SERVICE BULLETIN

N° **139-616**

DATE: June 19, 2024

ATA 53 - LOWER LH TAIL LONGERON INSPECTION AND REPAIR

Figure 3

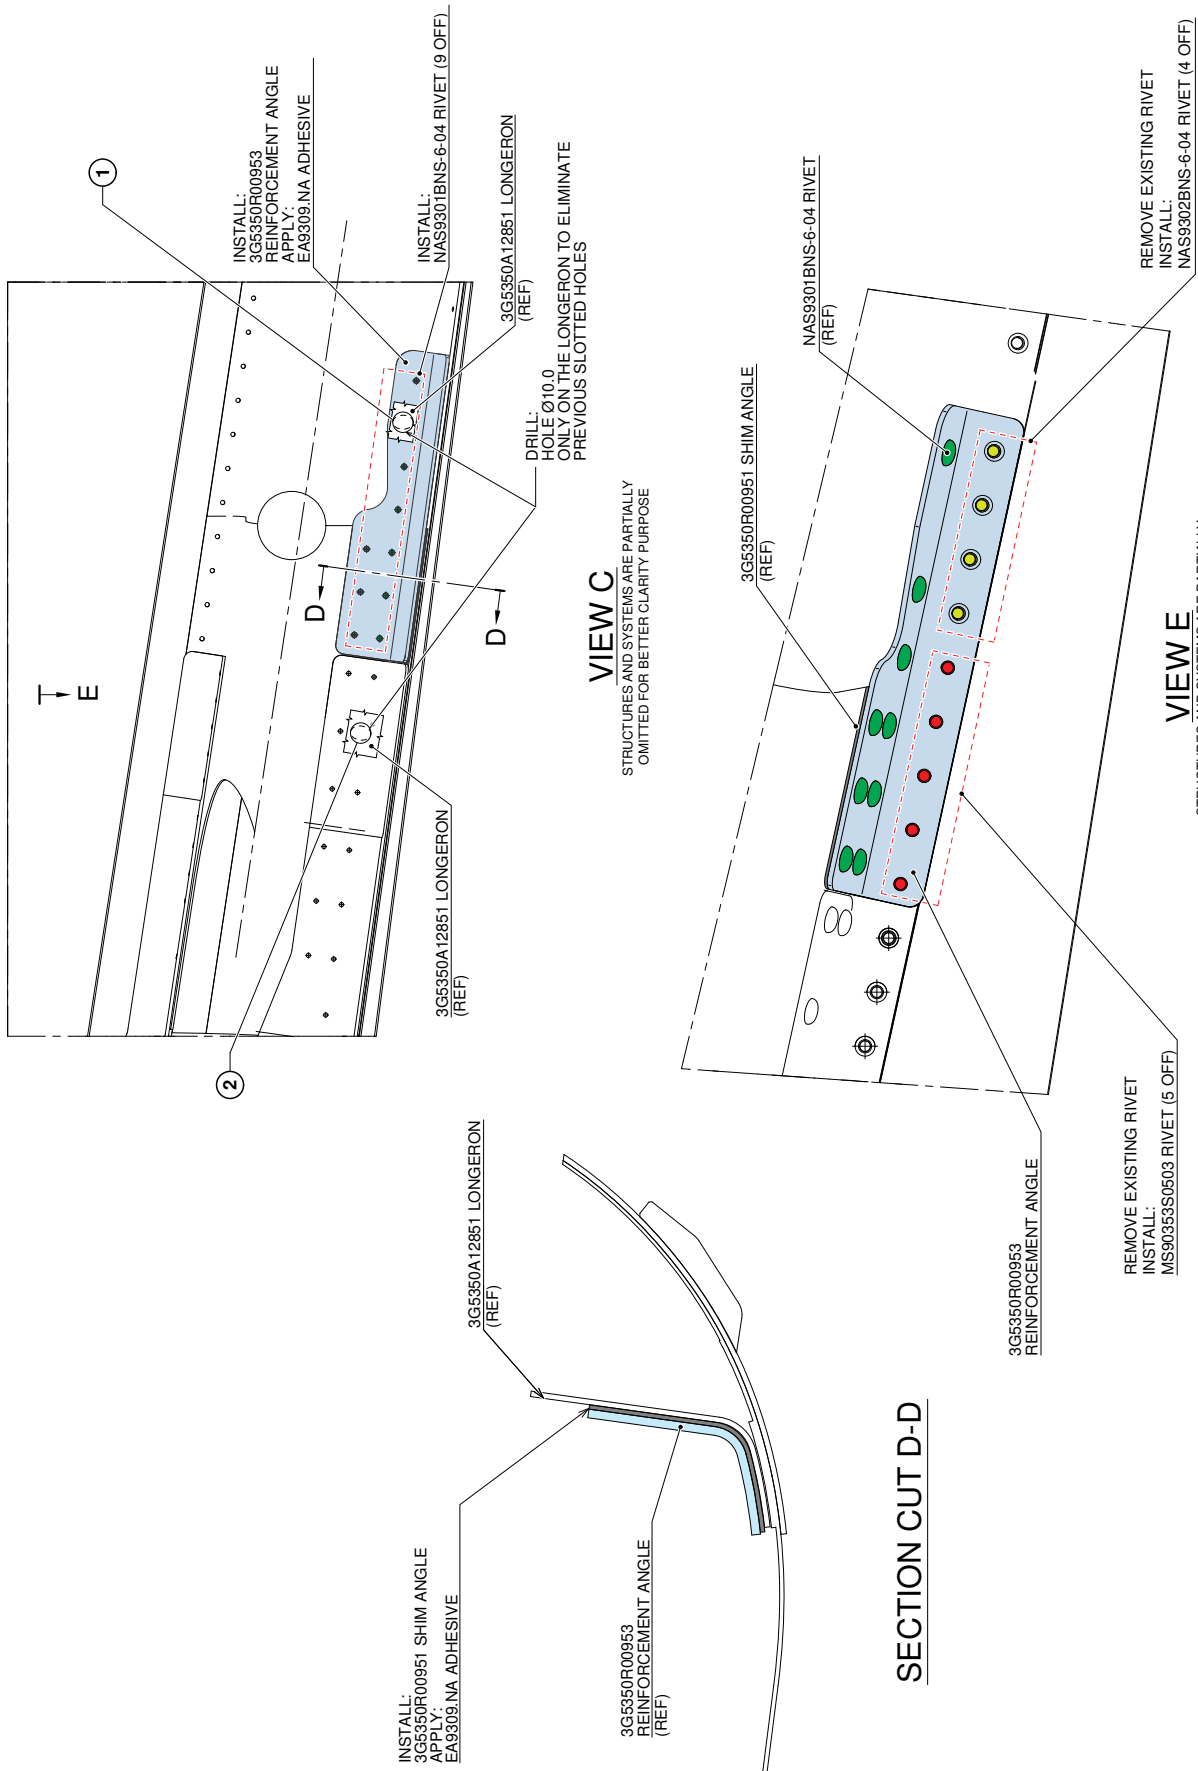
6. With reference to Figure 2 Detail A, drill out the indicated rivet.
7. With reference to Figure 2, in correspondence of previously removed rivet drill a hole \varnothing 3.25 normal to external profile on the longeron P/N 3G5350A12851 as indicated.
8. With reference to Figure 3 View C, from the internal side of the tail boom assy, widen the previously performed slotted hole up to \varnothing 10.0 only on the longeron.
9. With reference to Figure 2 Detail A, install rivet P/N NAS9302BNS-5-02 on the doubler P/N 3G5350A20351.

11. With reference to Figure 3 View E, drill out the indicated existing rivets.
12. With reference to Figure 3 View E, temporarily locate the shim angle P/N 3G5350R00951 and the reinforcement angle P/N 3G5350R00953 and proceed as follows:

13. With reference to Figure 3 Section D-D, install shim angle P/N 3G5350R00951 by means of adhesive EA9309.3NA (C021) on the longeron P/N 3G5350A12851.

14. With reference to Figure 3, install reinforcement angle P/N 3G5350R00953 by means of adhesive EA9309.3NA (C021), n°5 rivets P/N MS90353S0503, n°4 rivets P/N NAS9302BNS-6-04 or P/N NAS9302B-6-04 and n°9 rivets P/N NAS9301BNS-6-04.
15. Record the compliance with Part II of this Service Bulletin on the component log card.

Figure 4

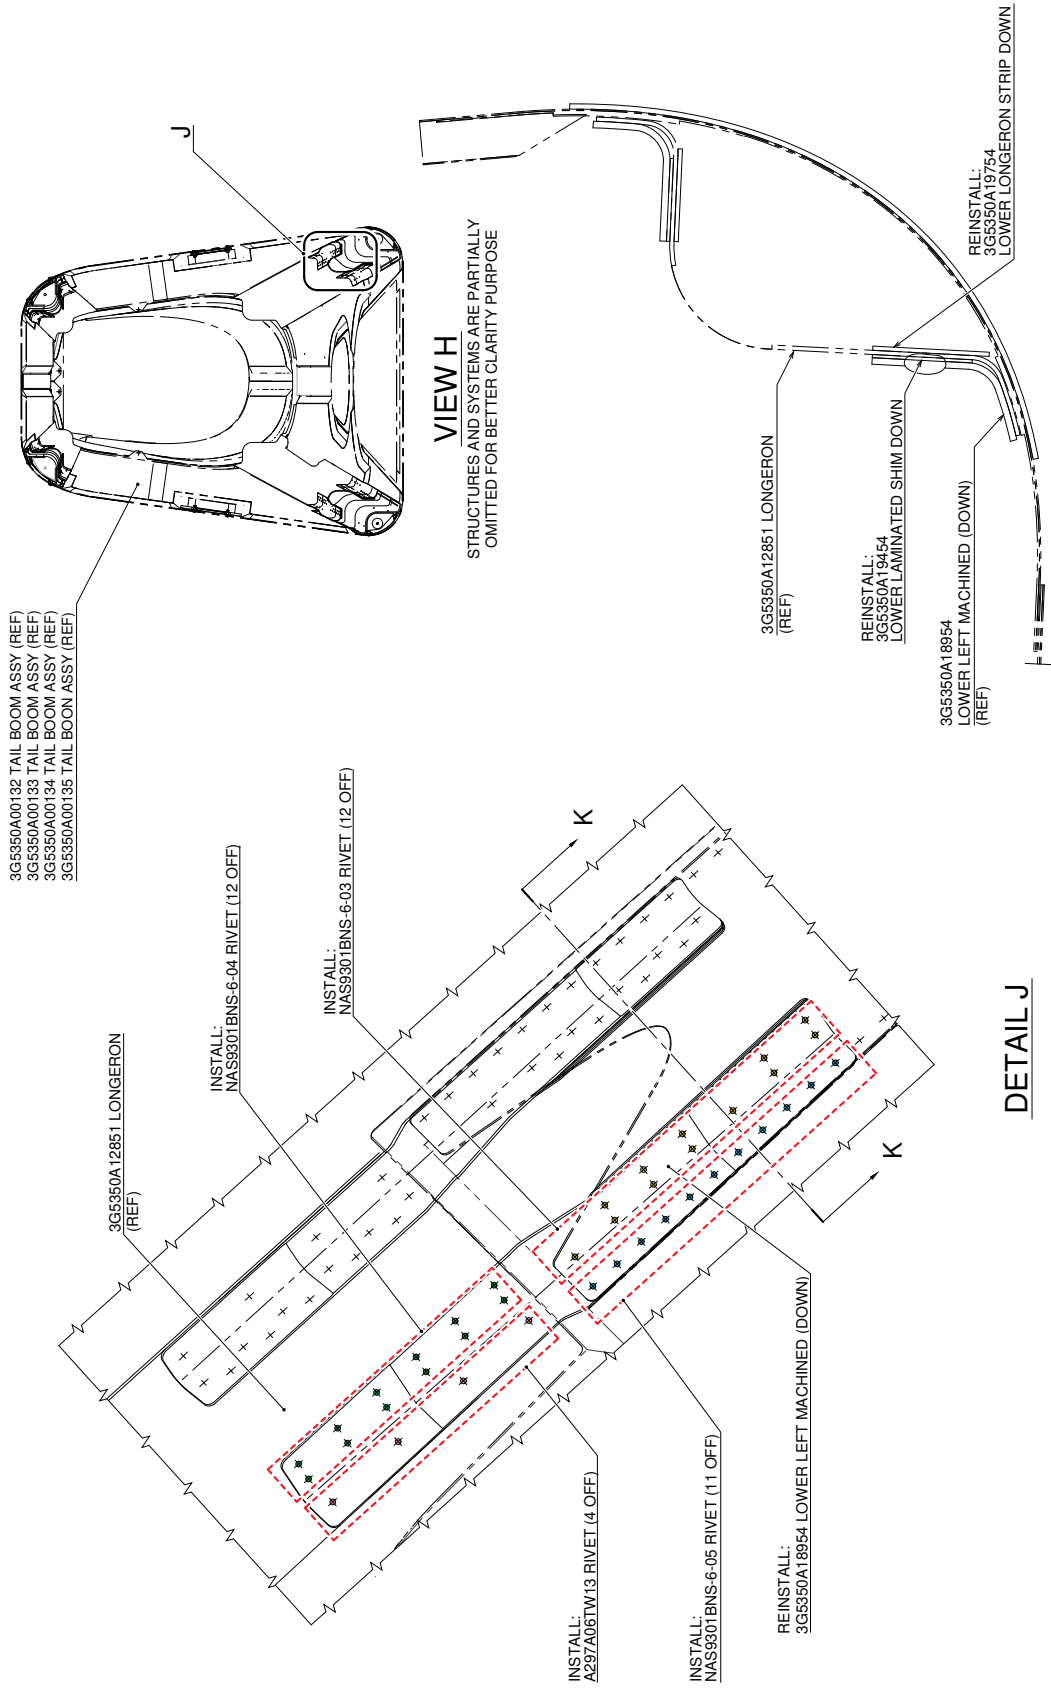
10. With reference to Figure 4, re-install lower left machined P/N 3G5350A18954, shim down P/N 3G5350A19454 and strip down P/N 3G5350A19754 by means of n°12 rivets P/N NAS9301BNS-6-04, n°12 rivets P/N NAS9301BNS-6-03 or P/N NAS9301B-6-03, n°4 rivets P/N A297A06TW13 and n°11 rivets P/N NAS9301BNS-6-05 or P/N NAS9301B-6-05 on the longeron P/N 3G5350A12851.

Figure 5

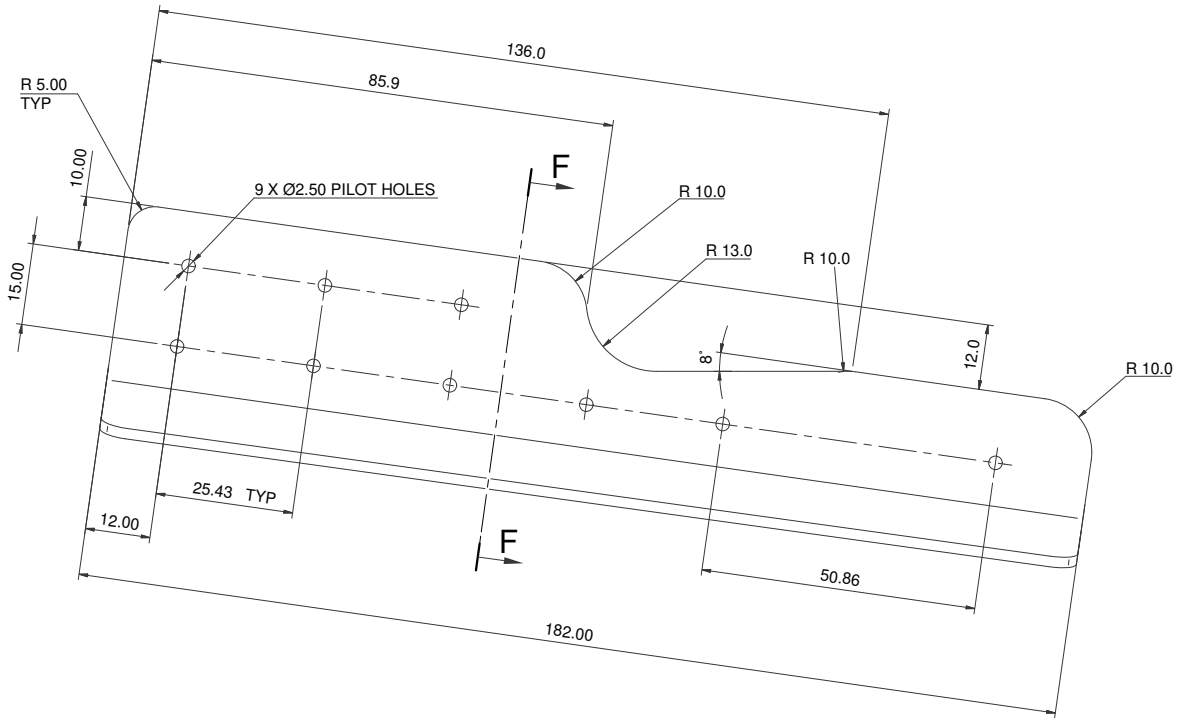
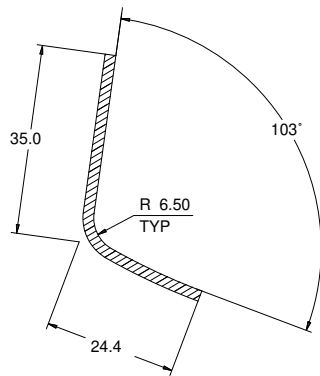
2. With reference to Figure 5, rework the reinforcement angle P/N 3G5350R00952 as indicated and mark it as P/N 3G5350R00953.

3. With reference to Figure 5, rework one plate AL-ALY 2024 (Thickness 2.00 mm) as indicated to obtain reinforcement angle and mark it as P/N 3G5350R00953.

Figure 6

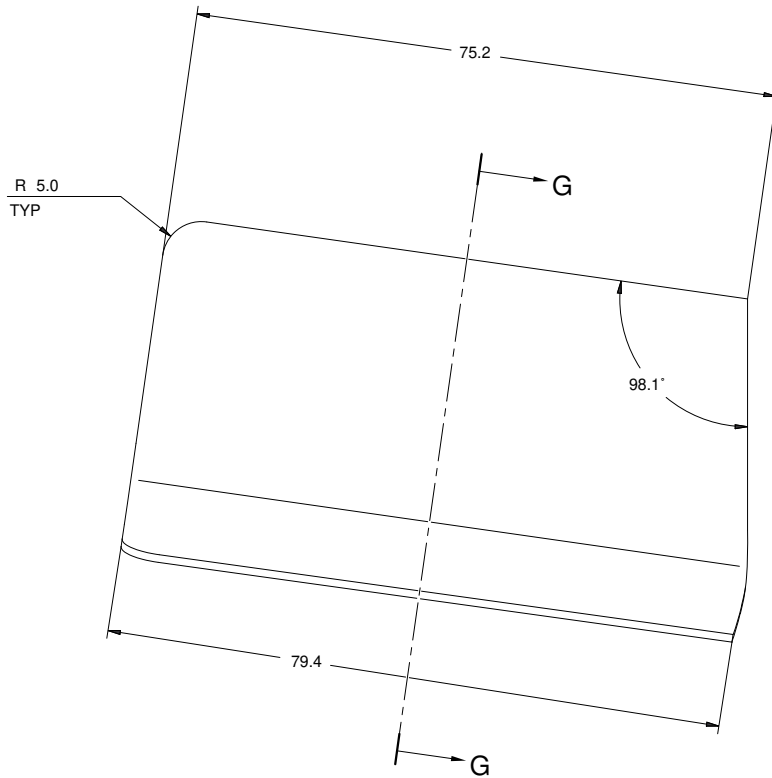
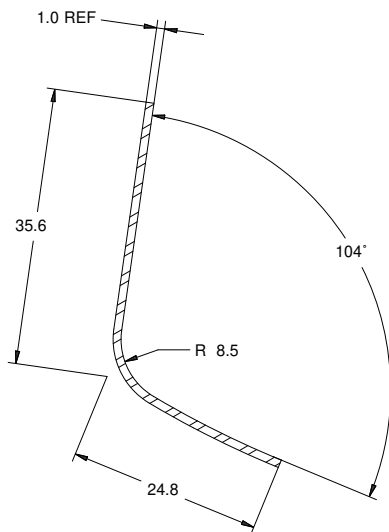
1. With reference to Figure 6, rework one plate AL-ALY 2024 (Thickness 1.02 mm) as indicated to obtain shim angle and mark it as P/N 3G5350R00951.

Figure 7

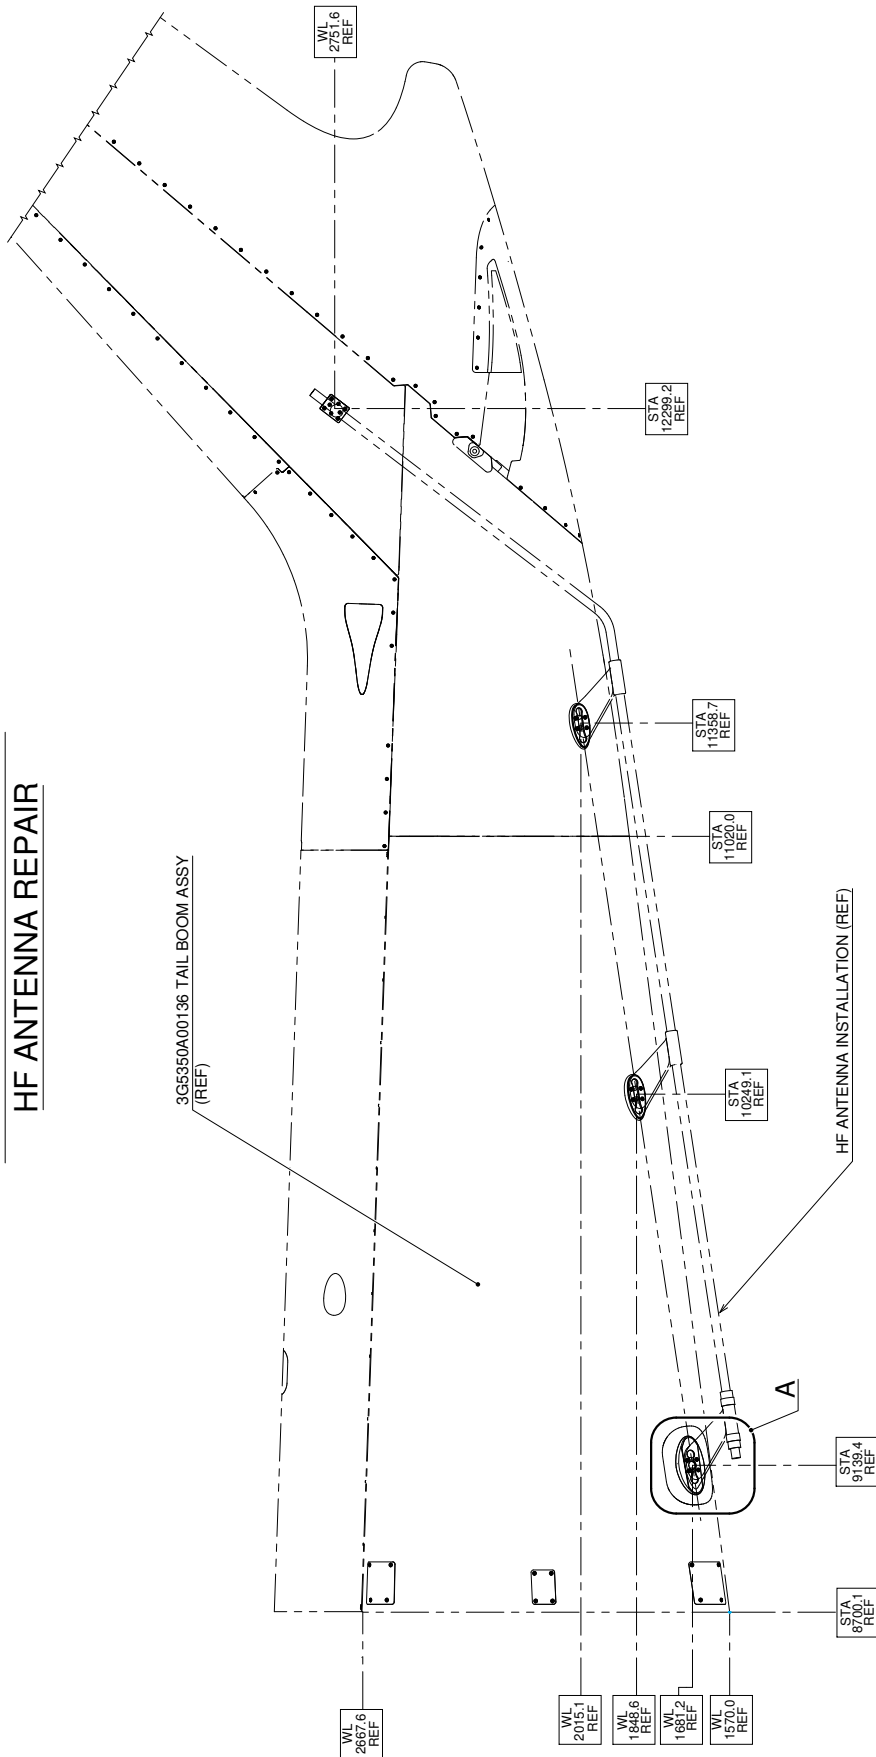
3. In accordance with AMP DM 39-A-06-41-00-00A-010A-A and with reference to Figure 7, remove all external panels, internal panels and internal liners as required to gain access to the area affected by the installation.

Figure 8

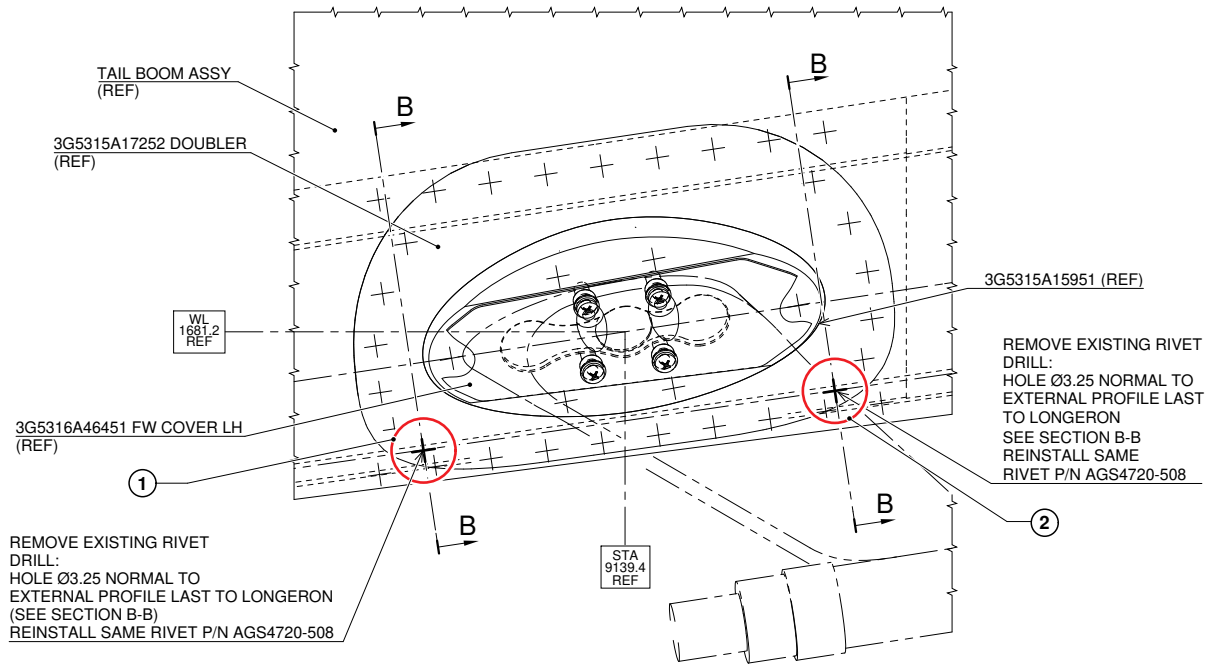
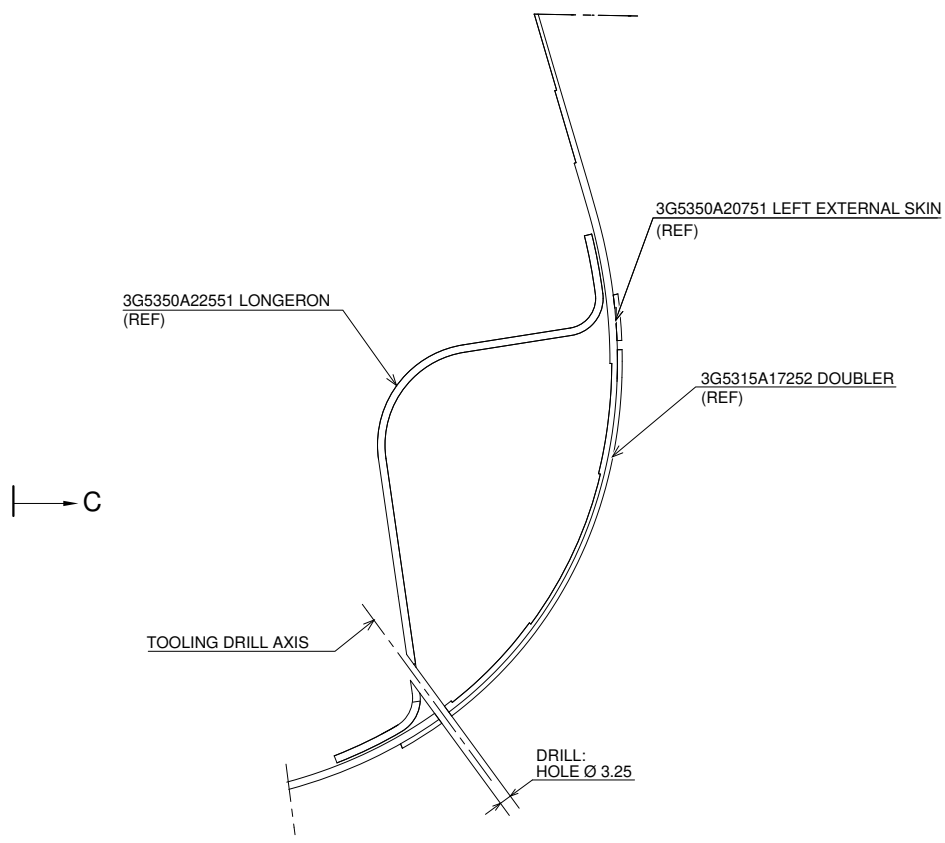
3. With reference to Figures 1 and 2 Detail A or Figures 7 and 8 Detail A or Figures 12 and 13 Detail A, perform a visual inspection to find drill marks on the internal side of the longeron in correspondence of the indicated rivets (location 1 and 2) as described in the following procedure:

- 3.1 With reference to Figure 2 Detail A or Figure 8 Detail A or Figure 13 Detail A, insert the boroscope inside the tail boom assy longeron passing through the hole on the FW cover LH or passing through the access panel 310BL.

4. With reference to Figure 8 Detail A, drill out the indicated rivets.
5. With reference to Figure 8, in correspondence of previously removed rivet drill a hole \varnothing 3.25 normal to external profile on the longeron P/N 3G5350A22551 as indicated.
6. With reference to Figure 9 View C, from the internal side of the tail boom assy, widen the previously performed slotted hole up to \varnothing 10.0 only on the longeron.
7. With reference to Figure 8 Detail A, install rivet P/N AGS4720-508 on the doubler P/N 3G5350A20351.
8. With reference to Figure 9 View E, drill out the indicated existing rivets.
